# **Scheduled Traffic State Machines to Support 802.1Qbu Frame Preemption**

**(Supplement for P802.1Q-rev/D2.0 comment #i-24, #i-27~i-32)**

**Tae-kyu Kang  
November 2017**

**Electronics and Telecommunication Research Institute (ETRI)**

Figure 8-13—Scheduled traffic state machines—overview and relationships

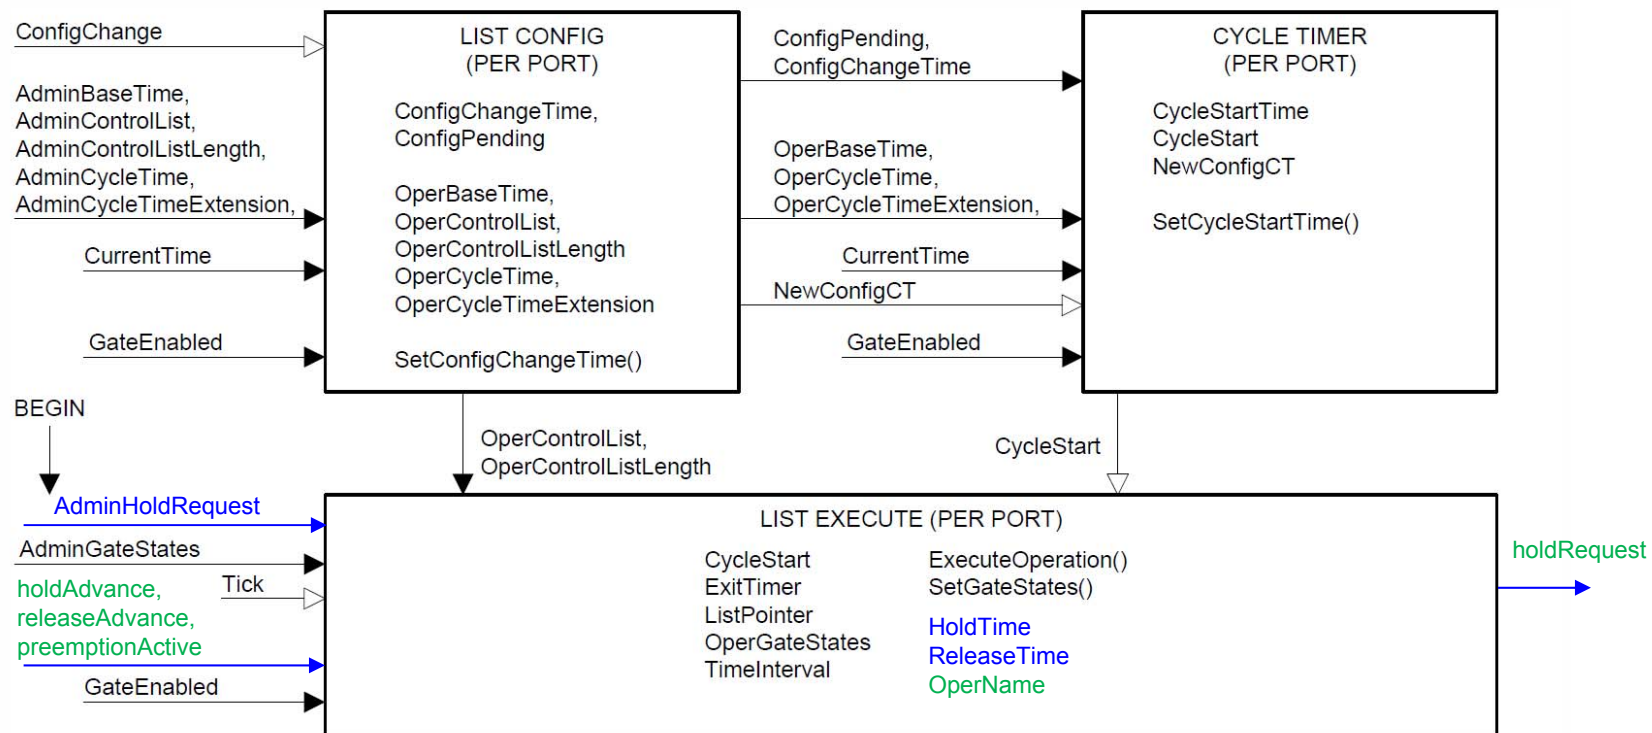
*Note: The blue and green letters are the proposed modifications (additions) to support frame preemption. The green ones are modified after TSN TG conference call (Oct. 16).*

Figure 8-15—List Execute state machine

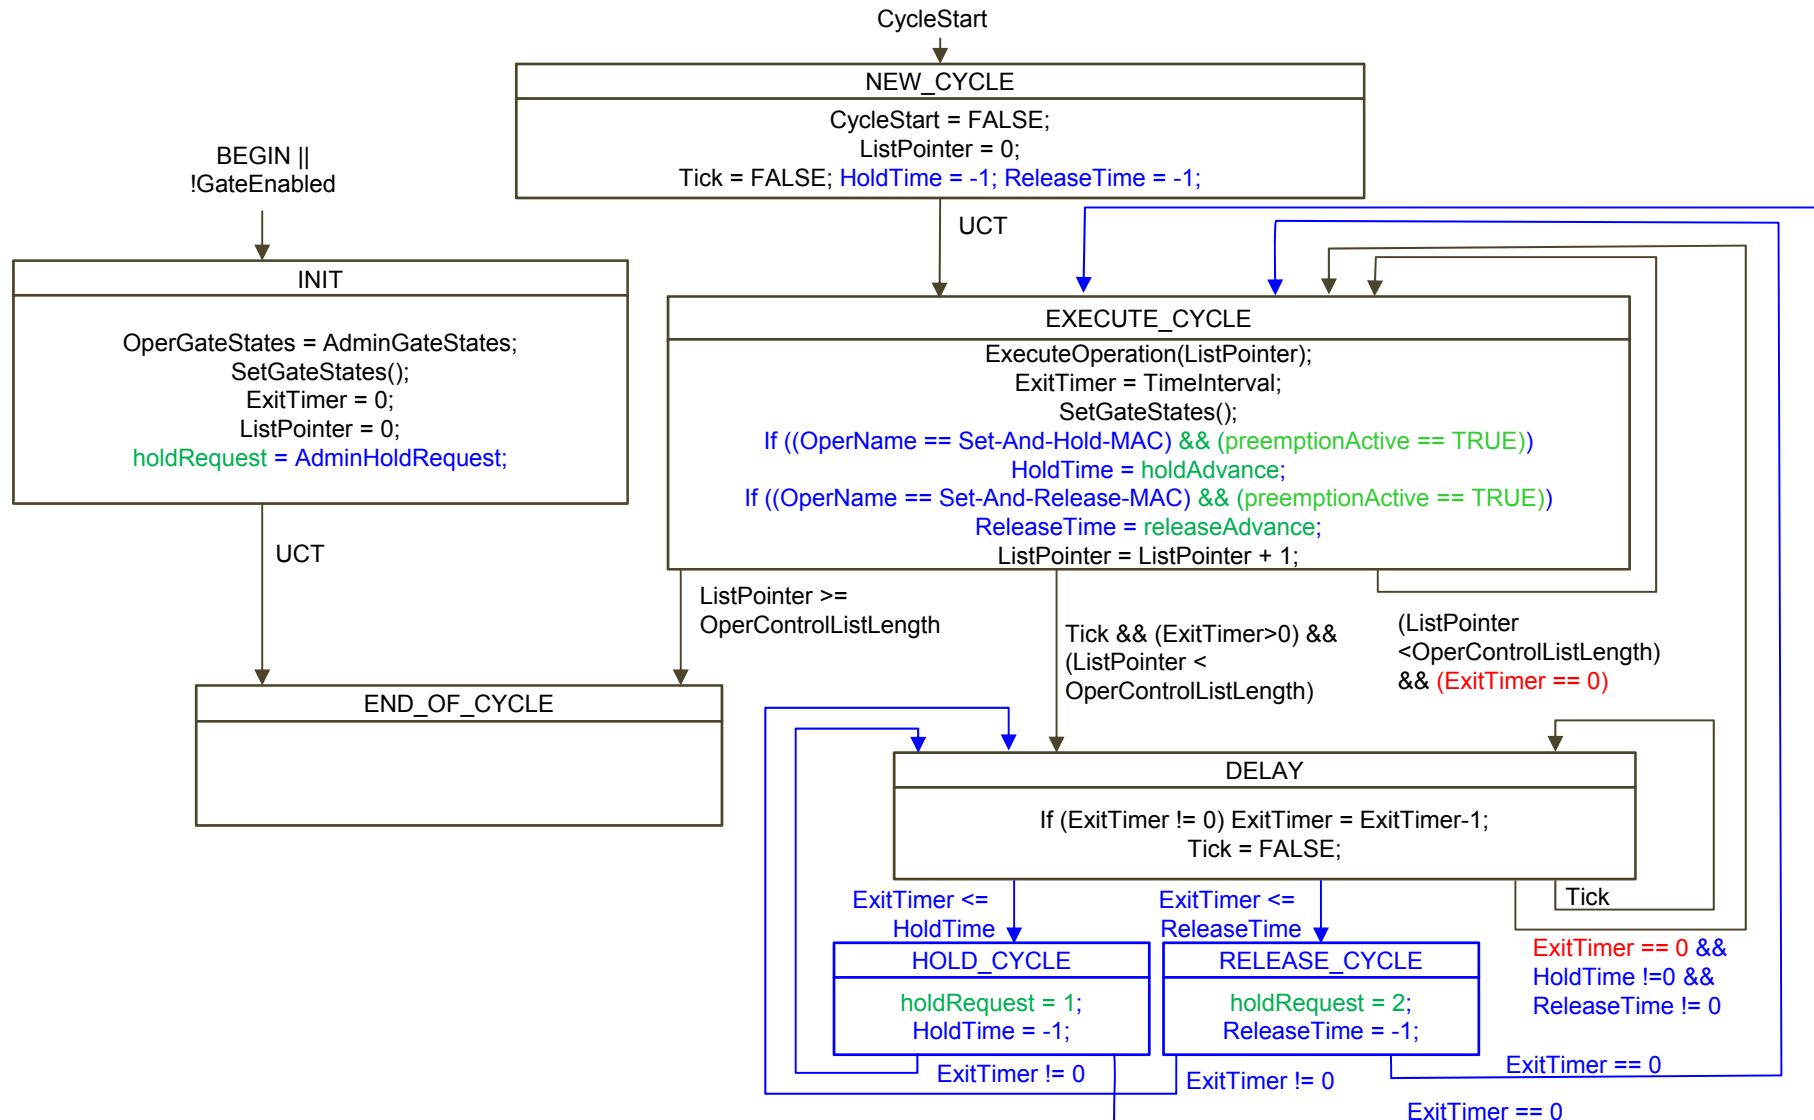
Note: The blue and green letters are the proposed additions to the existing figure.

The red ones replaces what are in the existing figure. The green ones are modified after TSN TG conference call (Oct. 16).
